29 January 2015

Federal Specification for the Star-of-Life Ambulance
KKK-A-1822F
Dated 1 August 2007
Change Notice 7

THIS CHANGE NOTICE IS CUMULATIVE, AND INCORPORATES ALL CHANGES INCLUDED IN CHANGE NOTICES 1-6. IT SUPERCEDES NON-CUMULATIVE CHANGE NOTICES 1-6, AND SHALL BE RETAINED UNTIL SUCH TIME AS THE STANDARD IS REVISED.

Add FIGURE 6

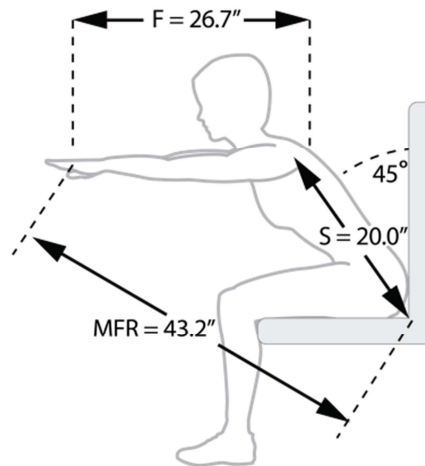
Maximum Functional Reach Maximum functional reach is measured from the center point of the junction of the seat pan and seat back to the thumb tip where the arm is fully extended parallel to the floor and the torso is leaning forward at a 45° angle. Maximum functional reach is calculated using the following formula, where F = functional reach and S = seat to shoulder sitting height.

As an example using anthropometric data from MIL-STD-1472G, the maximum functional reach for a 5th percentile female, illustrated below is calculated using the seat (bottom of buttocks) to shoulder torso length (20.0 inches [508 mm]) leaned forward at a 45° degree angle and a functional reach as measured from the shoulder blade to thumbtip (26.7 inches [677 mm]) for a maximum functional reach of 43.2 inches (1097 mm).

$$MFR = \sqrt{26.7^2 + \frac{2(26.7)(20)}{1.41} + 20^2} = 43.2 \text{ inches}$$

Seats and restraints should be designed to allow all EMSPs to reach patients with at least one hand at a maximum functional reach from a seated and restrained position. This includes a 5th female EMSP with a maximum functional reach of 43.2 inches as measured from the junction of the seat pan and seat back to the thumb tip of the arm fully extended parallel to the floor while leaning at a maximum 45° degree angle. (see figure 6)
